# Dixie-Narco®

## Service Bulletin # 272

MODELS: DN, DCB, DNCB, and DNC  
EXCEPT: DNCB 630/360-5 & -6

SUBJECT: Temperature Control - Revised  
(Cutler-Hammer)

Fig. 1

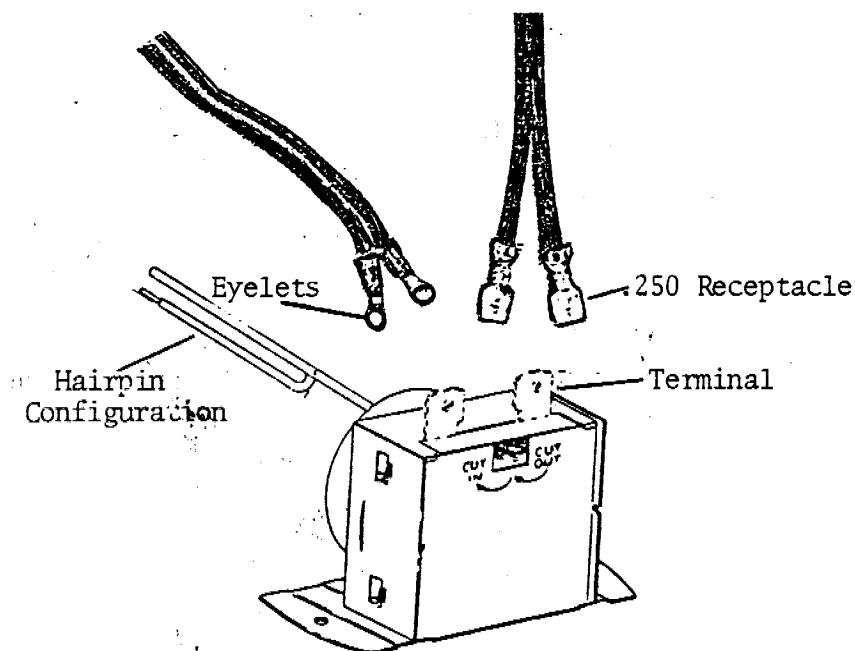
REASON: To provide a Temperature Control with:

1. Terminals that require push on leads, (See Fig. 1) instead of eyelet type leads.
2. Power element that has a hairpin type configuration instead of a coiled pigtail. (See Fig. 1)

TO INSTALL

- DO THIS:
1. Cut off eyelets.
  2. Wire strip, install, and crimp .250 receptacle.
